PROPOSED RESIDENTIAL REDEVELOPMENT
PHOENIX WORKS, CASTLEFIELD, MANCHESTER

Highways Technical Note 01

- 1.1.5 The highway-related comments are summarised in this Highways Technical Note 01 (HTN01) and a copy of the full consultation response from the LHA at MCC, dated 26th February 2021, is contained in **Appendix 1** to rear of this report.

Plan 2.1 – Crashmap Extract (2015-2019 Inclusive)

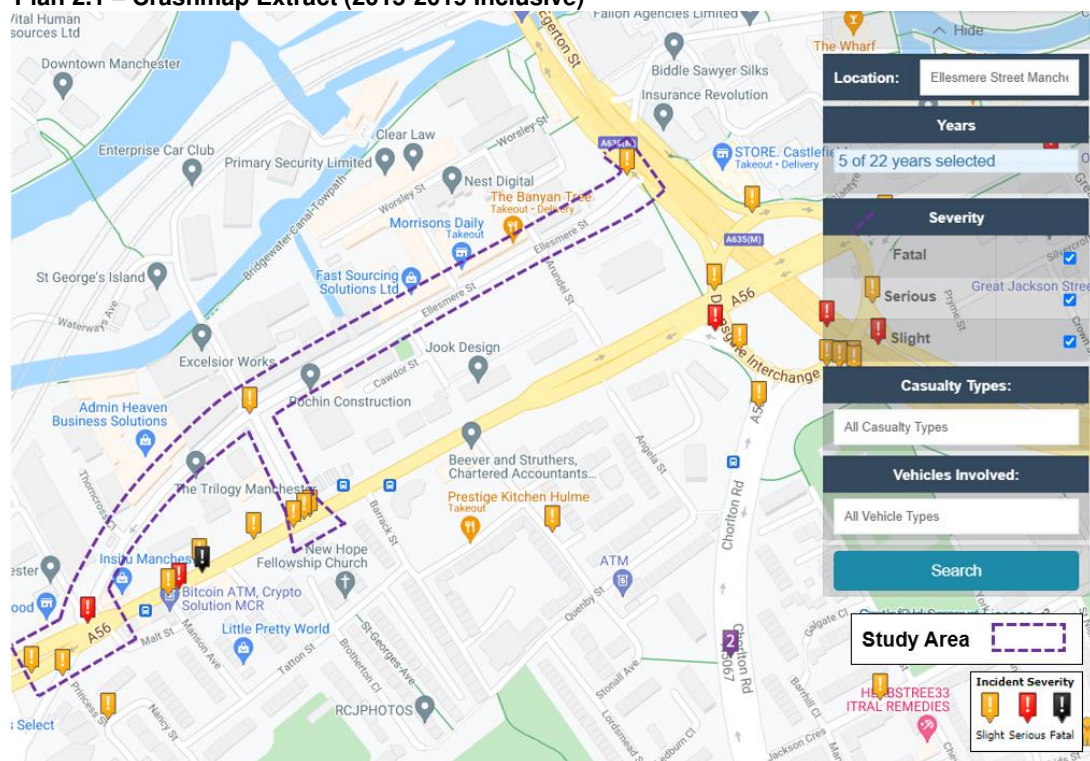
Information has been provided for the most recent 3 years. MCC Highways request that data on accidents for the last 5 years is provided - the TS should be suitably amended.

- 2.1.4 **Plan 2.1** demonstrates that the following accidents have been recorded within the identified study area between 2015 and 2019 inclusive:
- 1 'slight' accident at the Ellesmere Street / Hulme Hall Road junction;

- 3 'slight' accidents at the A56 Chester Road / Hulme Hall Road junction;
 - 1 'slight' accident at the Ellesmere Street / A57M Mancunian Way junction; and

- 2 'slight' and 1 'serious' accident within the vicinity of the A56 Chester Road / Ellesmere Street junction.
- 2.1.5 The evidence presented above therefore indicates that a total of 8 accidents have been recorded within the vicinity of the application site within the most recently available five-year period, of which 7 accidents were classified as 'slight' in severity, and 1 which was classified as 'serious'.

- 2.1.6 Volumetrically, this equates to 1-2 accidents per year, on average. This is not considered to represent a cause for concern in the context of the proposed development and also in view of the volumes of traffic that the A56 and the A57M normally (pre-covid) carry at this location (i.e., circa 23,823 and 48,221 two-way traffic movements per day on the A56 and M57M respectively).

- 2.1.7 Highway safety is not therefore considered to present a material concern in the context of the proposed development and should not be a ground for refusal.

APPENDIX 2 – DWG NO. 2904-01-D02 (CAR PARK DIMENSIONS)

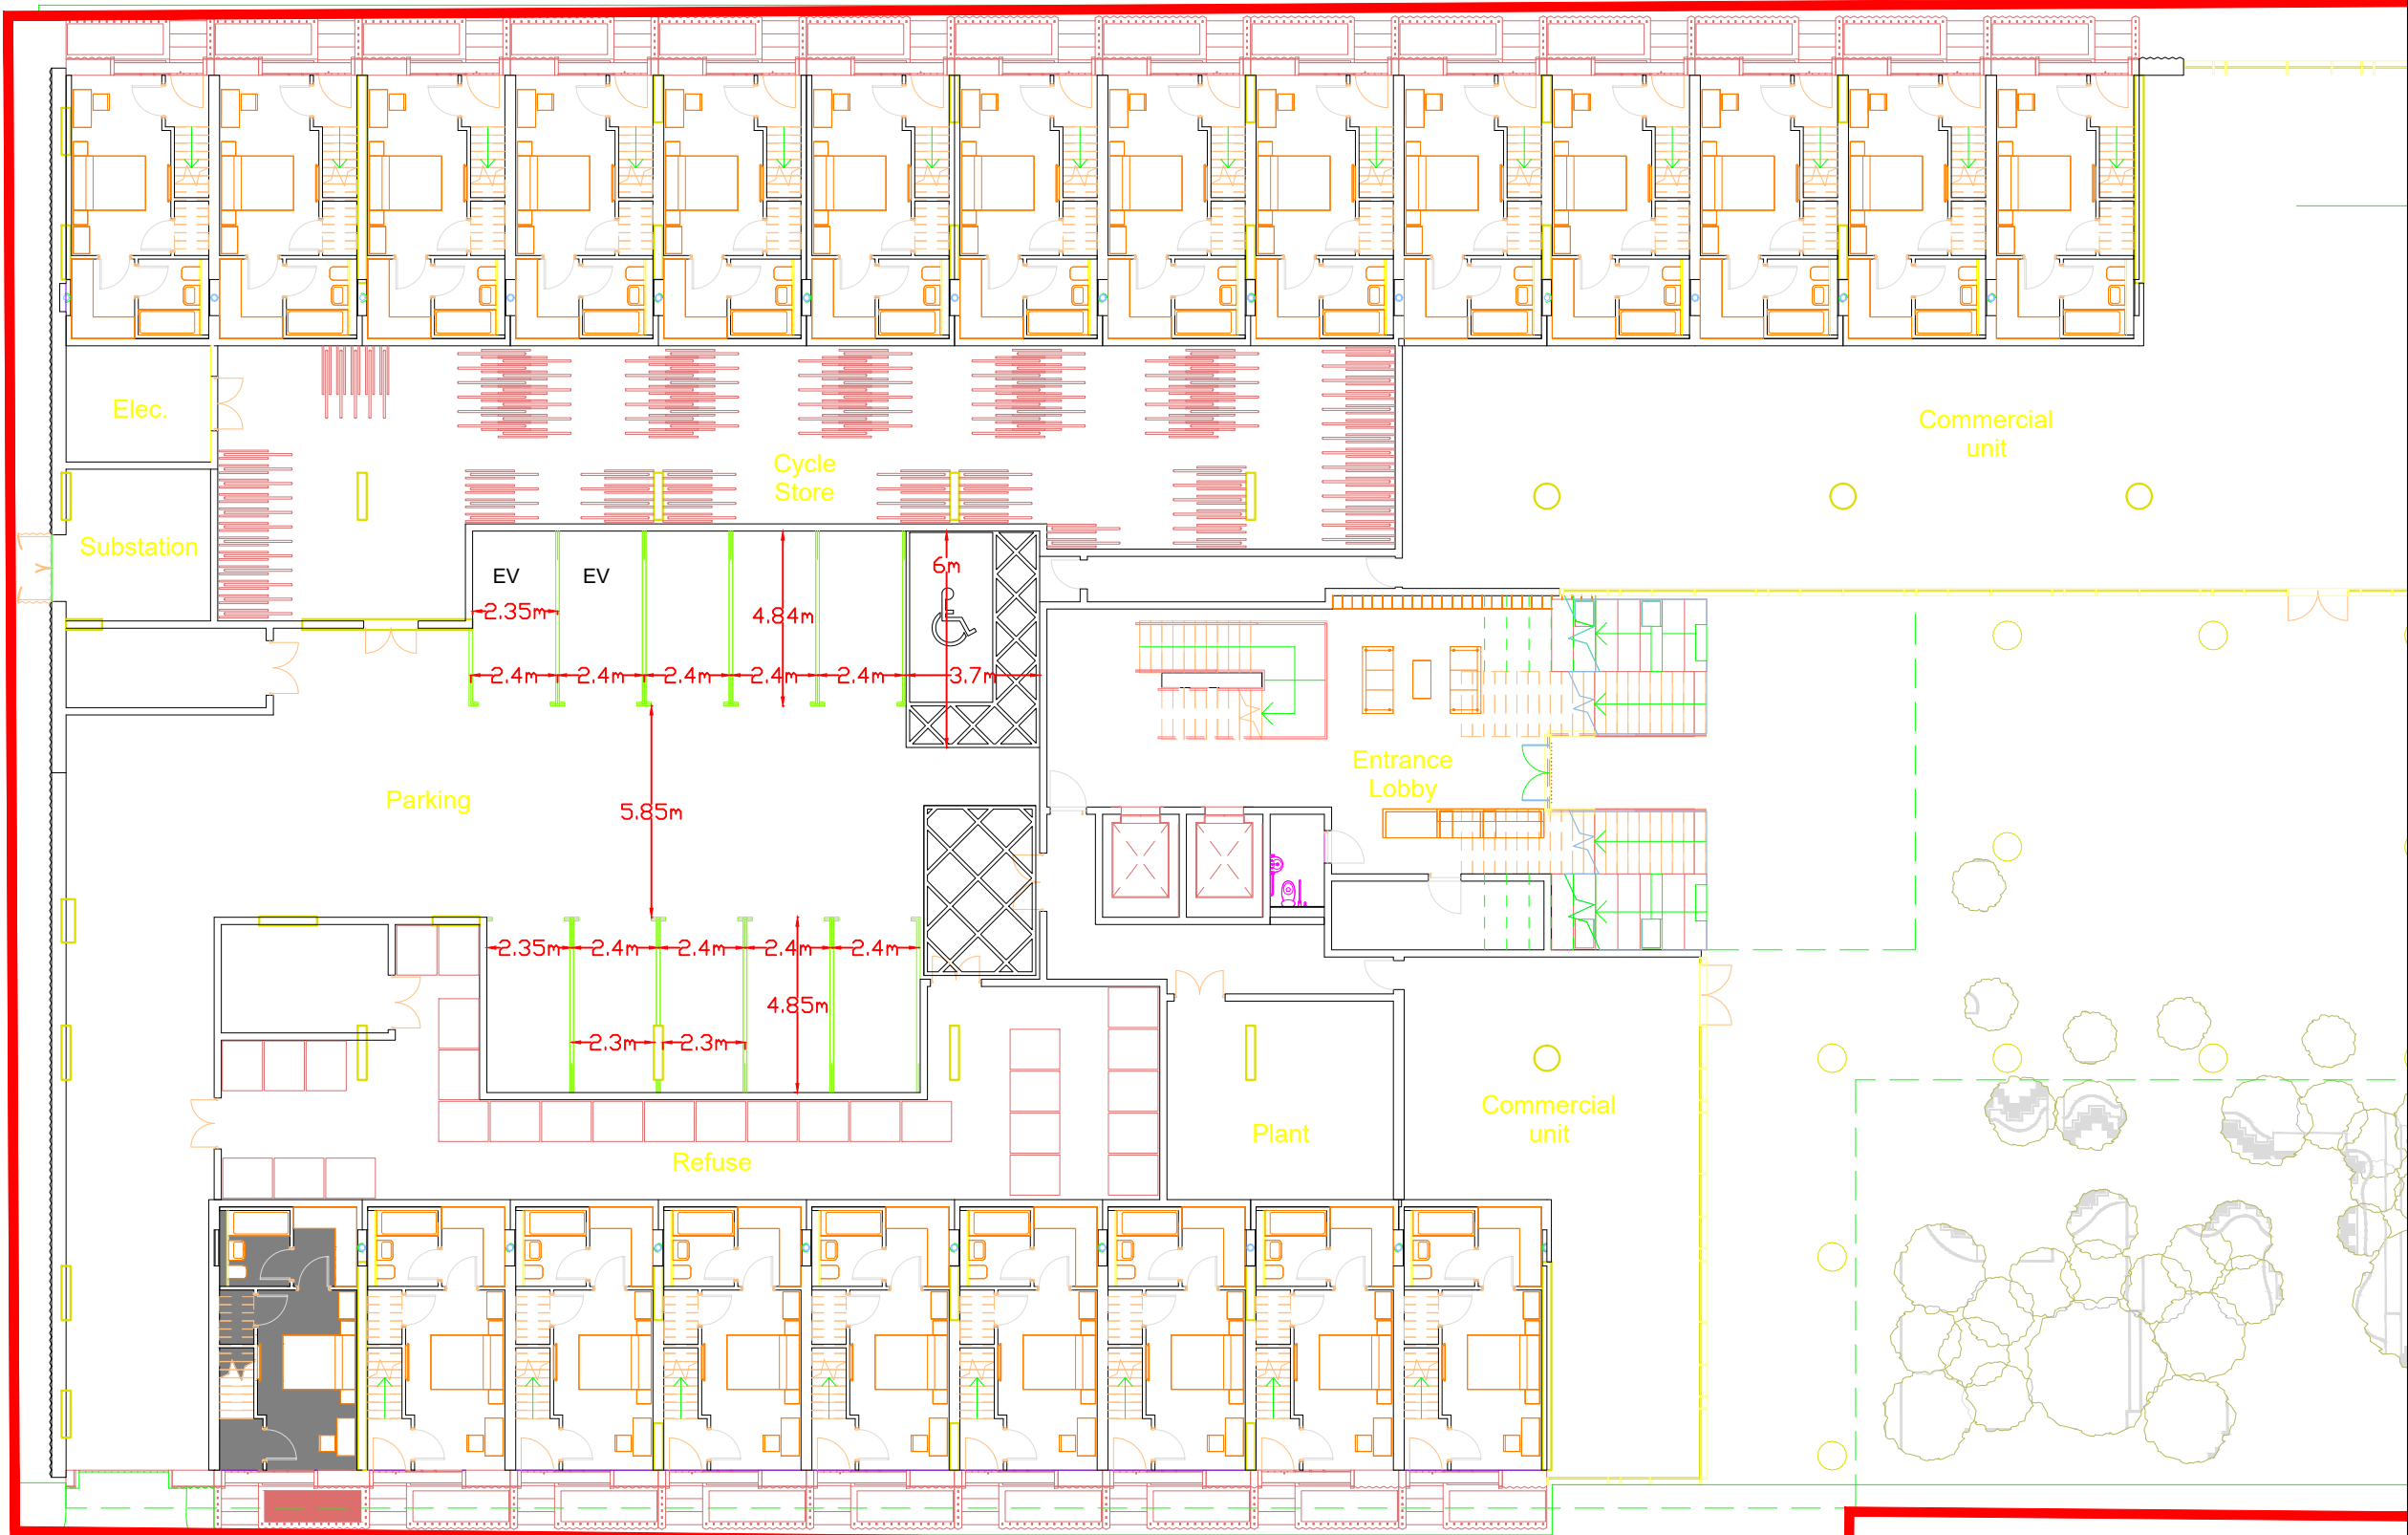
3.1.1 The LHA have requested confirmation that the proposed car parking bays are 2.4m x 4.8m, and that the accessible bay is 3.6m x 6m. Within the response, the LHA also state that the aisle should be a minimum of 6m wide.

The proposed development is to provide car parking located on the ground floor which provides space for 11 cars to park (circa 5% allocation), including 1 accessible bay and 2 Electric Vehicle Charging bays. Confirmation is sought that the bays are 2.4m x 4.8m and the accessible bay is 3.6m x 6m, the aisle should be a minimum 6m width.

3.1.2 The dimensions of the car parking bays and the aisle width are shown on **Drawing Number 2904-01-D02**, contained in **Appendix 2**. This demonstrates the following:

- The aisle width is 5.85m wide;
- The accessible car parking bay is 3.7m x 6m; and
- All other, standard car parking bays are 2.4m x 4.8m. It is, however, noted that three of the parking bays have pinch points as a result of their proximity to wall structures or structural columns. In these instances, the width of the parking bays reduces to a minimum of 2.3m for some parking spaces, albeit only for a short length (1.5m).

3.1.3 Whilst it is acknowledged that the aisle width is marginally below the minimum width identified by MCC (i.e. by 0.15m), **Drawing Number 2904-01-ATR01B (Appendix 3)** demonstrates the ability of a large car to safely and satisfactorily access all of the car parking spaces located within the car park, without encroaching onto nearby bays. This therefore demonstrates that all car parking bays would be accessible at any one time and so the dimensions of the proposed car park are therefore considered to be acceptable in their current form.

**APPENDIX 5 – DWG NO. 2904-01-D03 (SITE ACCESS JUNCTION VISIBILITY
SPLAYS)**

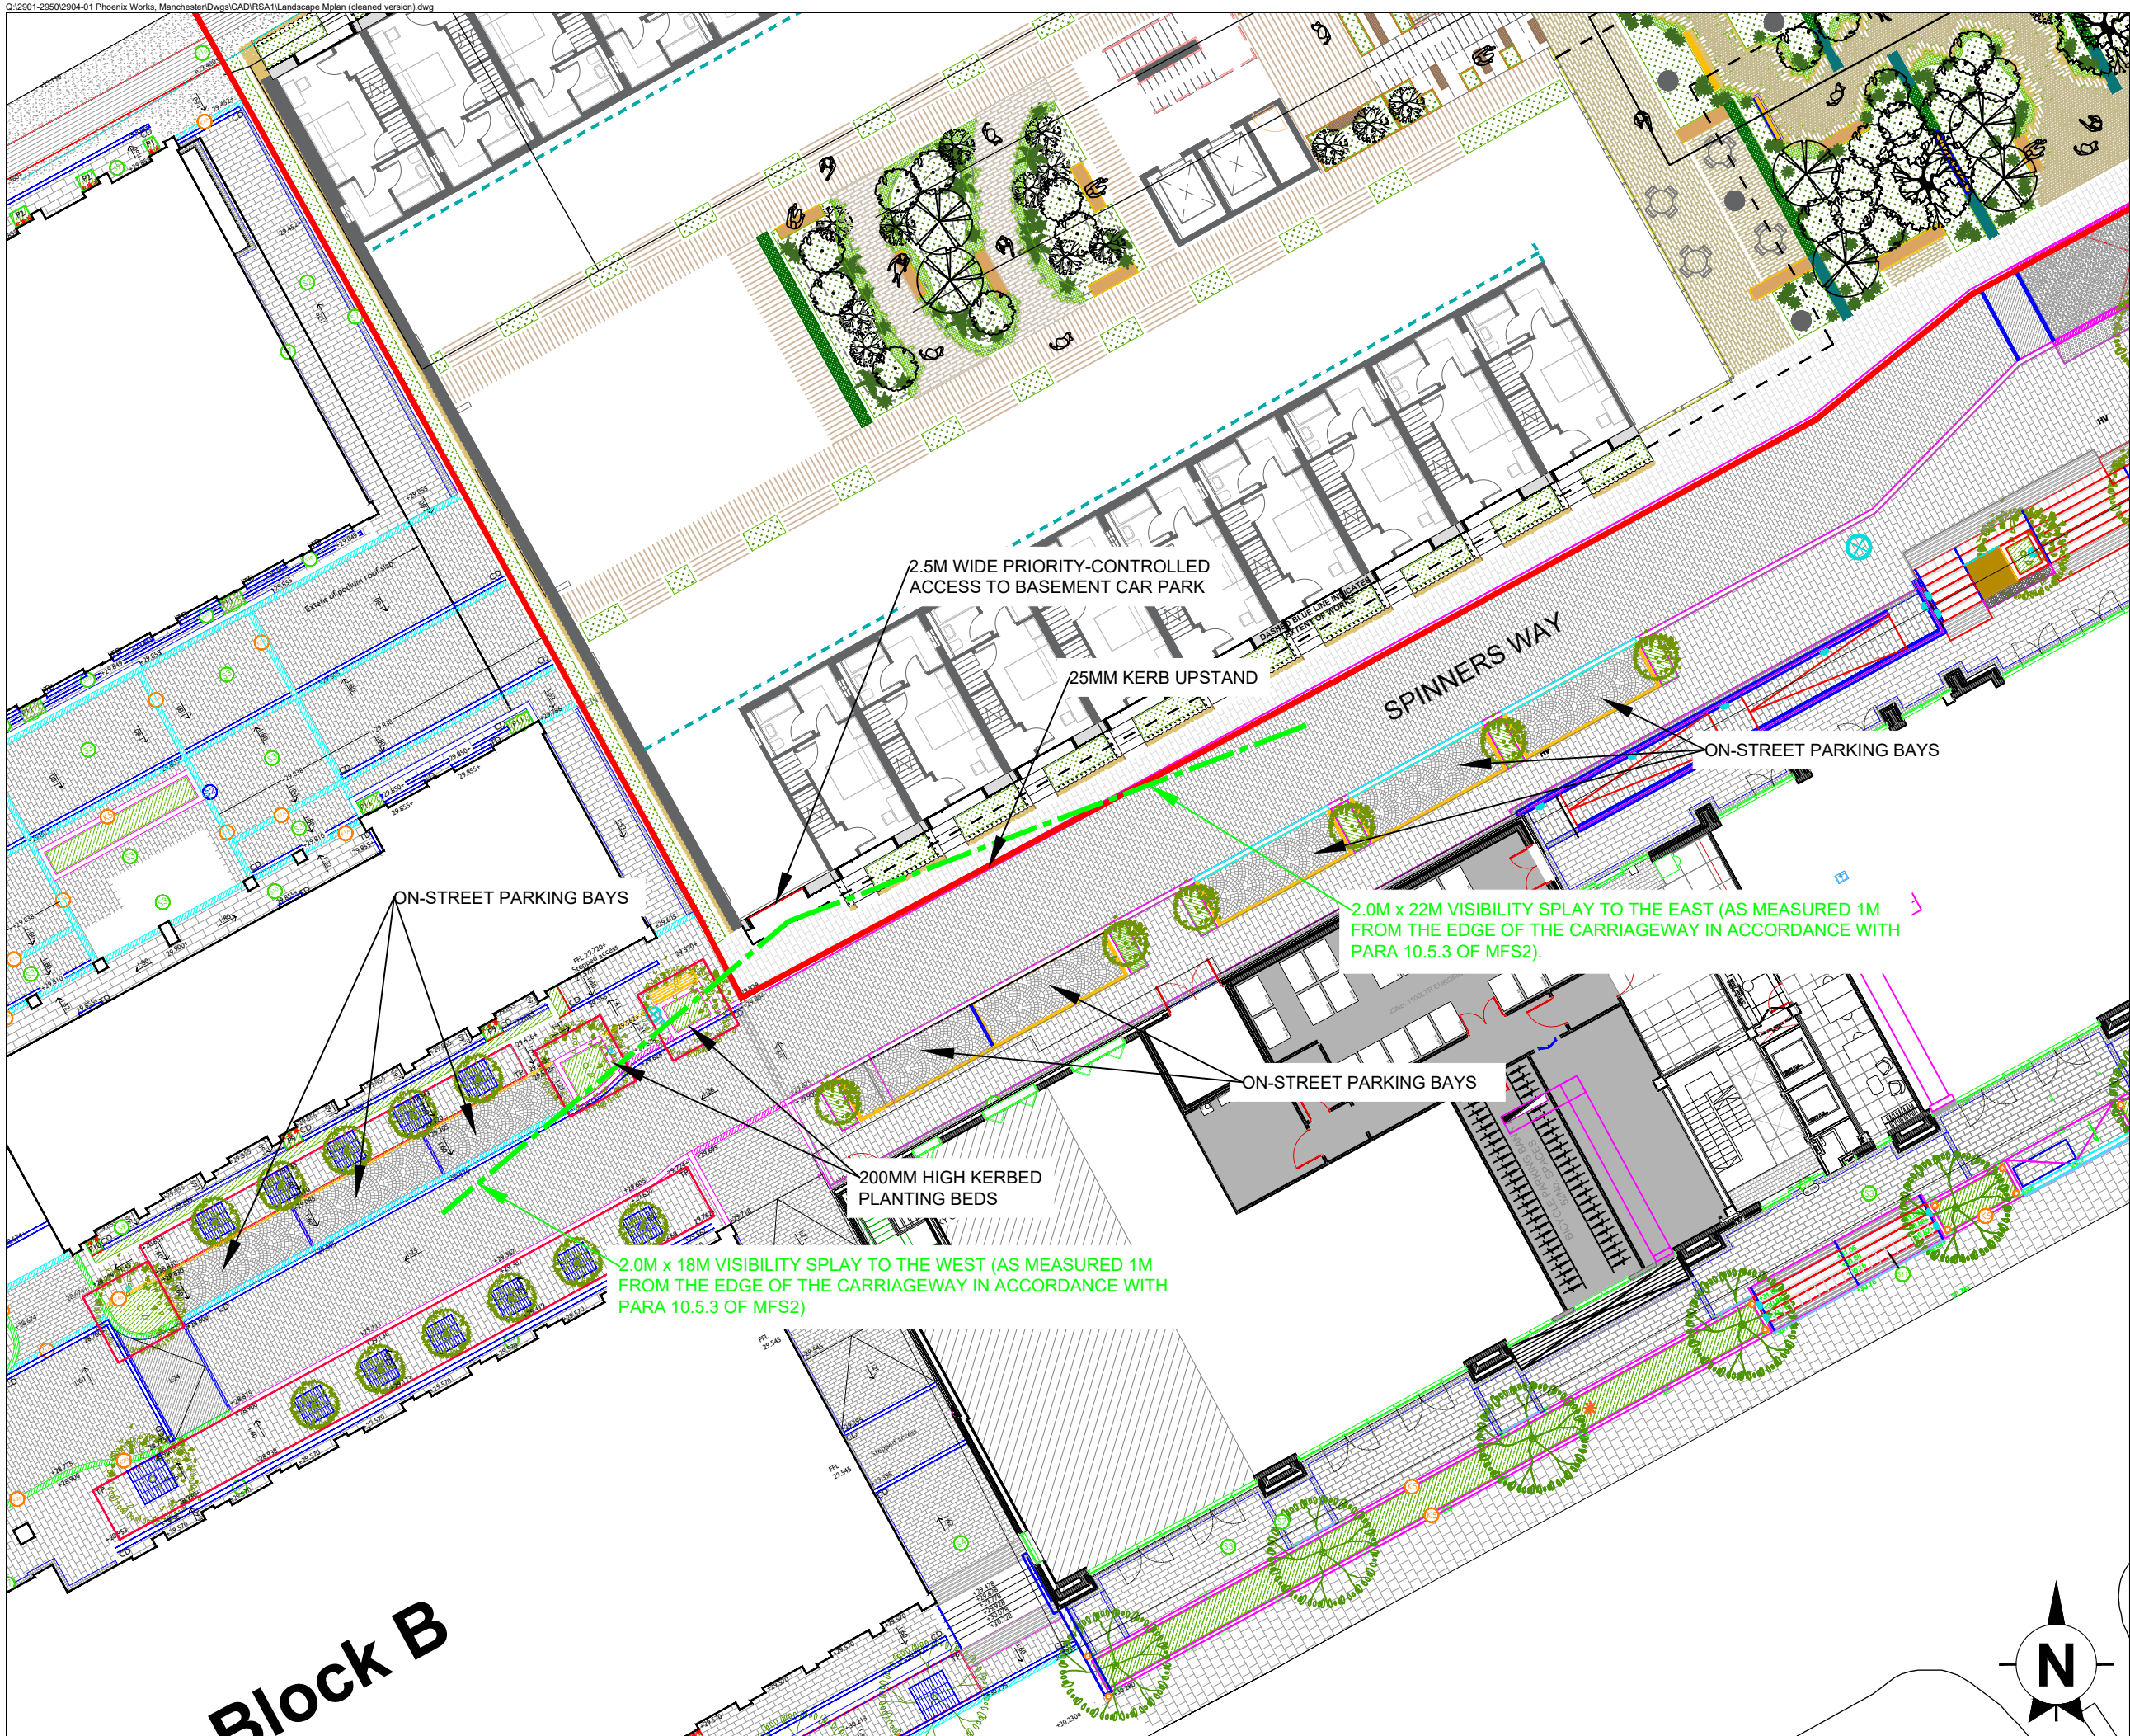
- 5.1.2 Within the consultation response from the LHA at MCC, confirmation is requested regarding the achievability of appropriate visibility splays for vehicles exiting the site. The LHA also state that protection TROs should be in place at either end of the access to ensure the appropriate visibility splays are maintained.

The applicant should confirm that appropriate visibility splays can be achieved when vehicles are exiting the site, junction protection TROs should be in place at either end of the access to ensure the appropriate sight distances are maintained.

- 5.1.3 **Drawing Number 2904-01-D03 (Appendix 5)** demonstrates that the following levels of junction visibility will be achievable from the proposed site access:

- 2.0m x 22m to the east, as measured 1m from the edge of the carriageway in accordance with the anticipated design speed of the road of 20mph or less; and

- 2.0m x 18m maximum achievable visibility to the west, as measured 1m from the edge of the carriageway.
- 5.1.4 The extent of visibility that is achievable to the west, from a 2.0m set back, is affected by the on-street parking bays that are located along this section of Spinners Way.

APPENDIX 6 – SOUTH EAST ELEVATION DRAWING

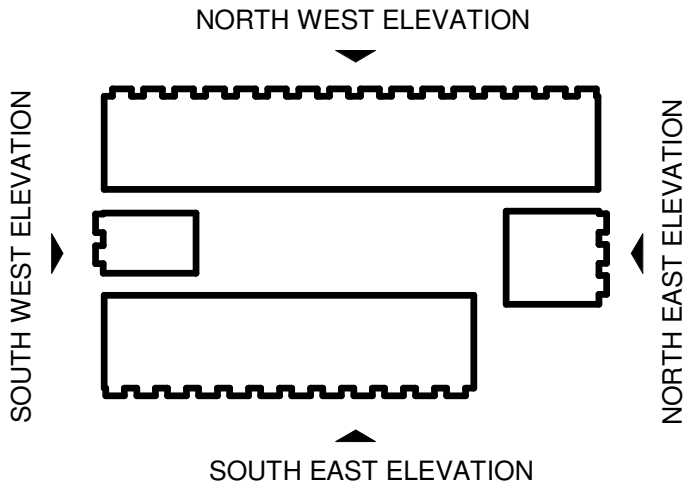
- 5.1.5 To the east, the visibility splay is partially obscured by the landscaping fronting the adjacent dwelling. For information, the southeast building elevation is contained in **Appendix 6** which illustrates in detail the low-level landscaping planter bed and steps to the east of the site access.

- 5.1.6 This shows that the adjacent properties are bound by a 600mm planter (significantly below typical driver eye height of 1.05m for car drivers) with see-through railings above.

- 5.1.7 Given the height of the proposed planters and the railings above, the visibility to the east will therefore only be partially obscured, and this is not considered to represent a cause for concern when viewed in the context of guidance contained in paragraph 7.8.6 of MfS, which states that *‘occasional obstacles to visibility that are not large enough to fully obscure a whole vehicle or a pedestrian, including a child or wheelchair user, will not have a significant impact on road safety’*. Fundamentally, this will not materially obscure the view of an oncoming vehicle, cyclist or pedestrian.
